**Revision of Manuscript Number:** IEEE-TPWRS-01391-2021, version 1 January 9, 2022  
**Journal:** IEEE Transactions on Power Systems  
**Author:** Abhishek Halder, Kenneth F. Caluya, Pegah Ojaghi, Xinbo Geng

### Response to decision:

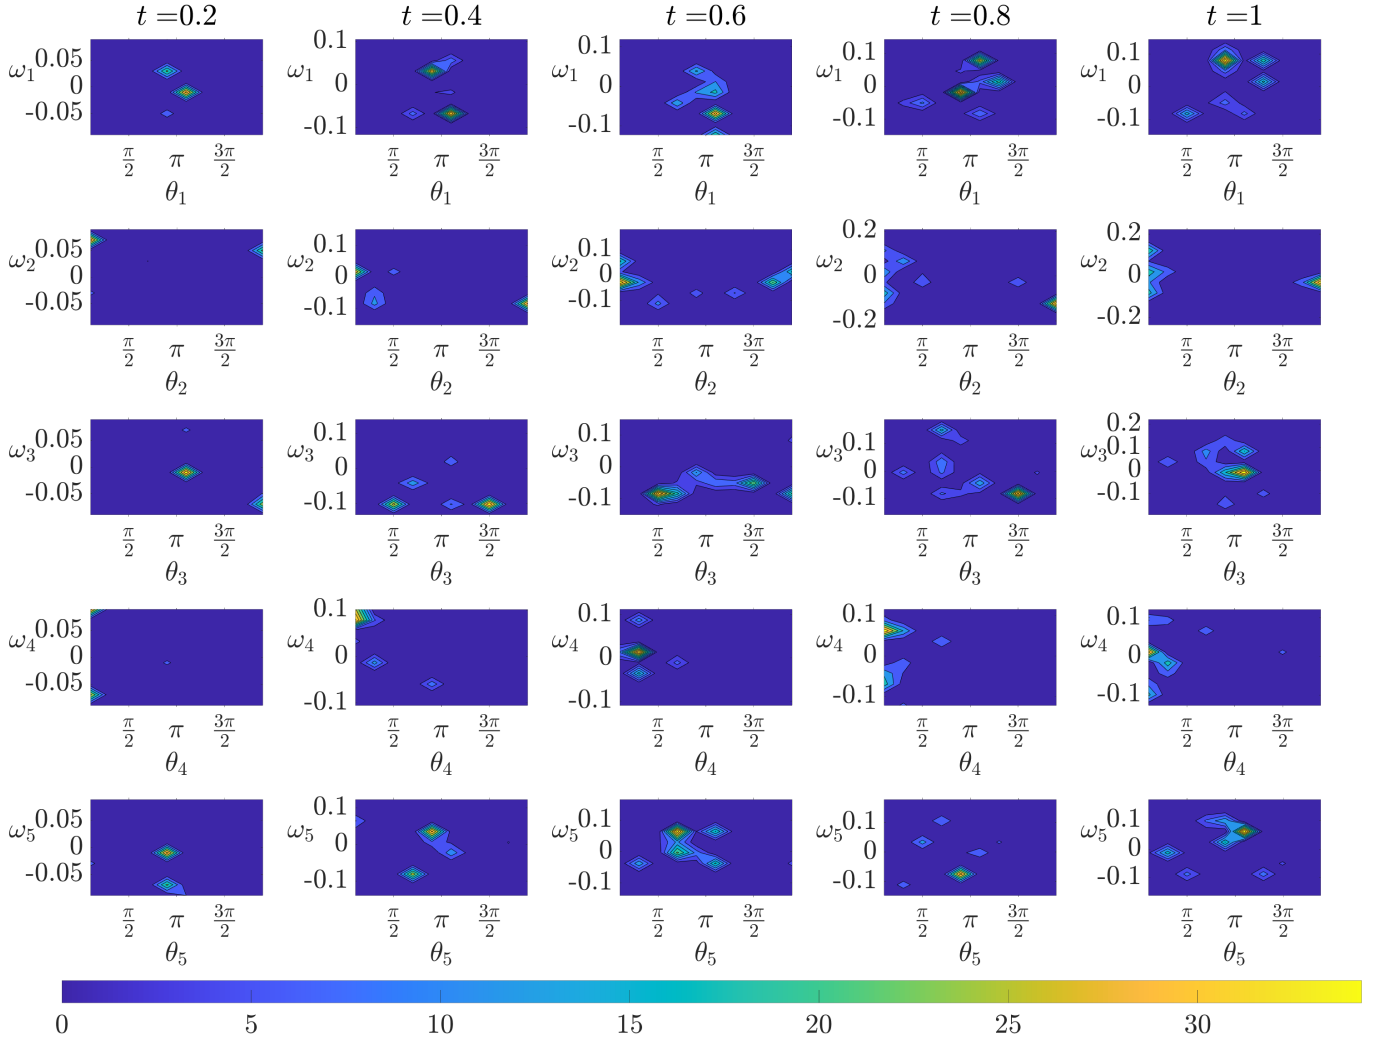
*Figures 5 and 6 are unreadable.*

**Response:** Thanks for this comment. In the previous version, the strict 10 page limit enforced small figure sizes. In the revised manuscript, Figures 5 and 6 are made larger. Also, the Fig. 6 in the revised manuscript shows the transient  $(\theta_i, \omega_i)$  bivariate marginals for all the five generators in Case II; the previous version showed the same only for the generator 4 (bus 6). We believe these changes have improved clarity.

Regarding the style of plots, we had considered plotting the bivariate marginals as planar contour plots (as in Fig. 1 in this rebuttal document) but decided against it because of the following two reasons.

First, in our opinion, this kind of plot is scientifically misleading as they hide the fact that these bivariate marginal PDFs are not really supported on the plane, or the subsets thereof, but instead have cylindrical supports. Our message that the proposed method explicitly accounts this manifold geometry in the computation, would be missed had we chosen to make the plots as per populist cognitive bias on behalf of the readers. That the planar plots evoke a sense of familiarity cannot be a scientific argument in favor of it.

Second, the planar contour marginal plots require additional mental efforts from the readers to correctly parse the statistical information conveyed. For instance, consider the fourth column, second row subplot in Fig. 1 in this rebuttal document. It is upon the reader to parse that the two high probability regions on the left and right of that subplot are actually referring to the same angular high probability region around  $\theta_2 = 0$  rad, thanks to the periodic boundary condition on the angular variable. Our philosophy of technical communication is that the onus is on the authors, not on the readers, to clarify the scientific information as correctly as possible. And yes, we are aware that many papers in the power system literature make plots in the rectangular domain ignoring the manifold nature of the support, which in our experience, continue to add pain to the graduate students and beginning researchers trying to decipher the statistical meaning conveyed in those plots. We thus prefer to make plots that depict the variables as they are.
